CHANG & ARENSBERG 2ND ADDITION

WICHITA, SEDGWICK COUNTY, KANSAS

RE: SUB 2002-35-- Final Portion of Overall Preliminary Plat of Chang and Arensberg Second Addition

At the regular meeting of the Subdivision Committee of the Metropolitan Area Planning Commission on Thursday, April 25, 2002, the above captioned plat was considered. The action of the Committee was to approve the one-step final plat, subject to the following:

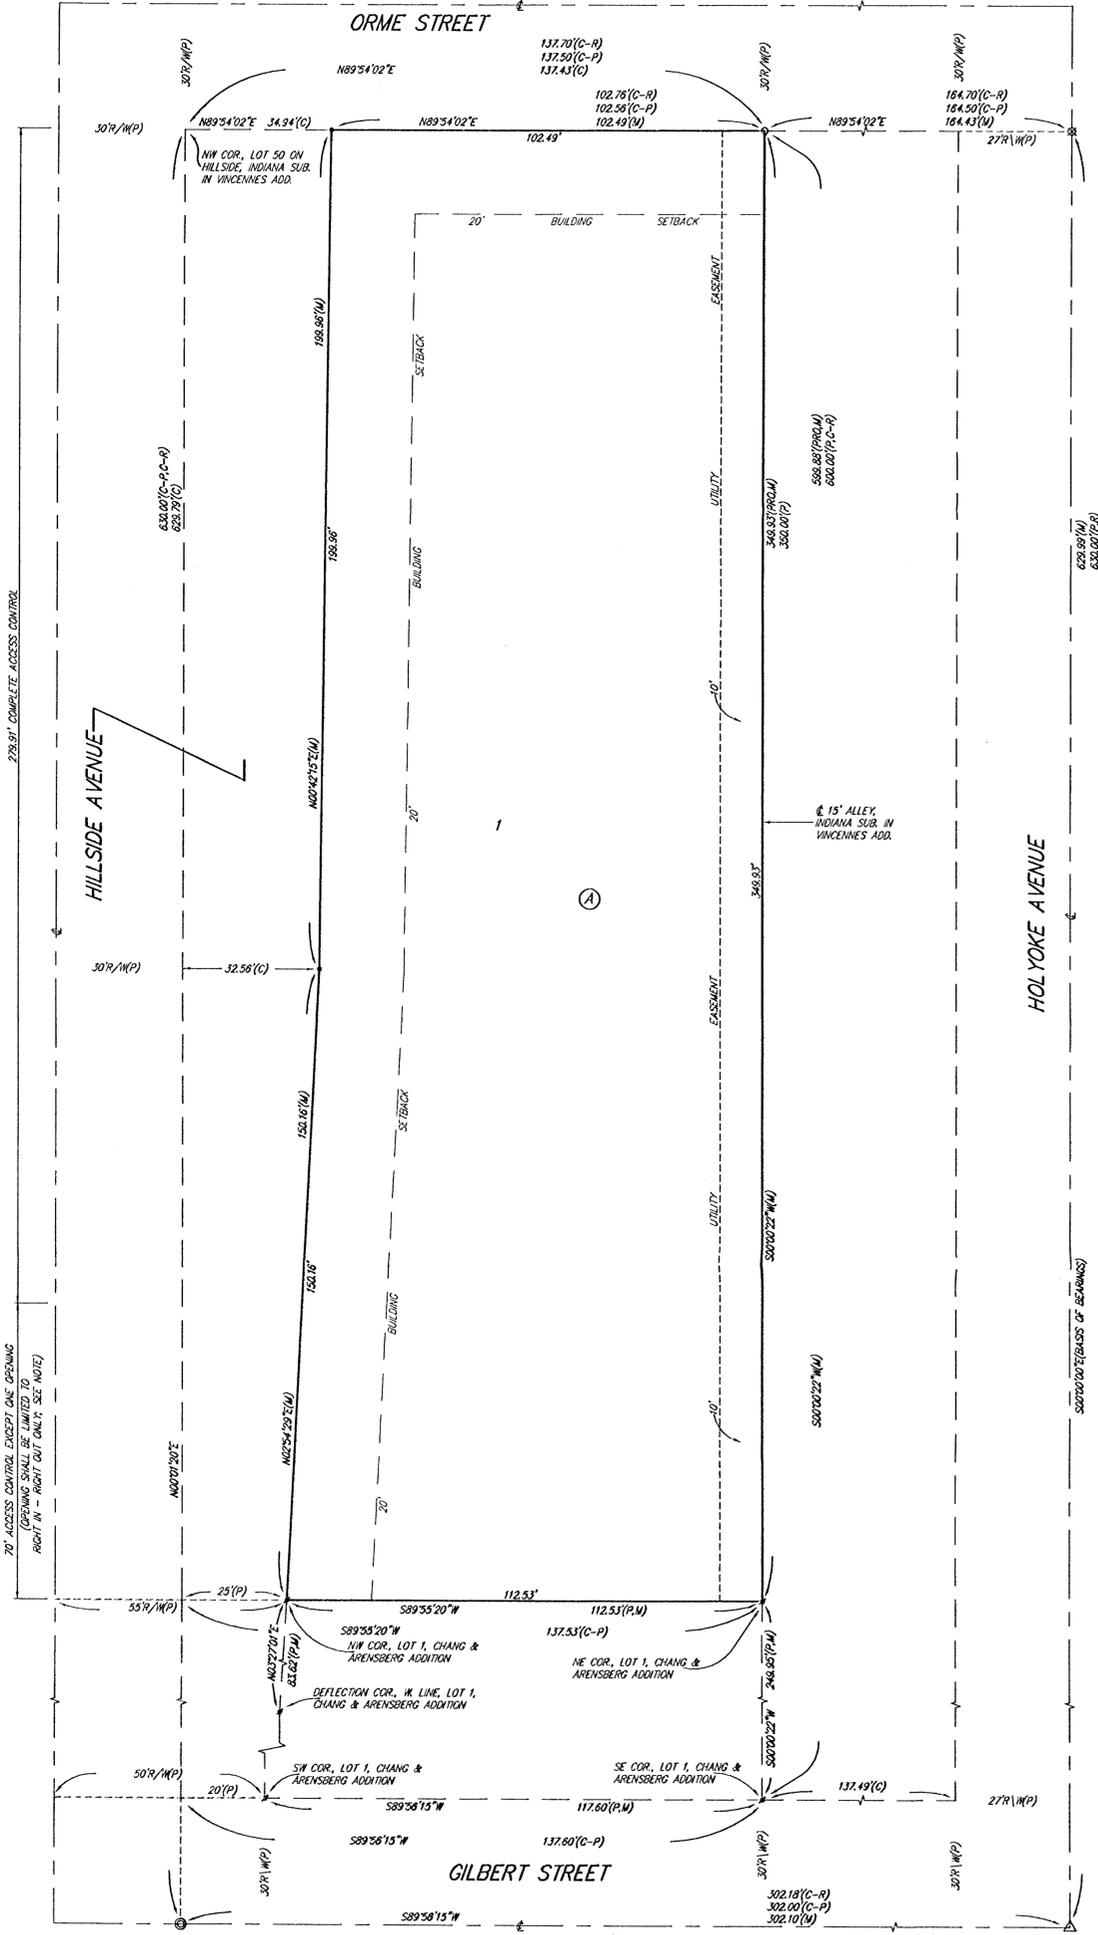
- A. Municipal services are available to serve the site. **City Engineering** needs to comment on the need for guarantees or easements. *Fees in lieu of assessment regarding water connection is required; or in the alternative a petition may be provided for extension of water main.*

- D. **City Engineering** needs to comment on the status of the applicant's drainage plan. *The drainage plan is approved.*
- E. The applicant proposes one opening along Hillside limited to rights-in/rights-out along the south line of the plat. *The access controls are approved.*

- F. A cross-lot access agreement shall be provided with the property to the south in accordance with the zone change approval.
- G. As a commercial plat adjacent to a non-arterial street, the Subdivision regulations require a sidewalk along Orme. *A sidewalk certificate is needed.*

- I. County Surveying has advised that the benchmark needs an elevation denoted.
- J. All owners that are denoted on the application have not been included as signatories to the plat. These owners need to be added to the final tracing or documentation provided that such interests are no longer involved with this site.

- K. The platting text shall include language that a drainage plan has been developed for the plat and that all drainage easements, rights-of-way, or reserves shall remain at established grades or as modified with the approval of the applicable City or County Engineer, and unobstructed to allow for the conveyance of stormwater.
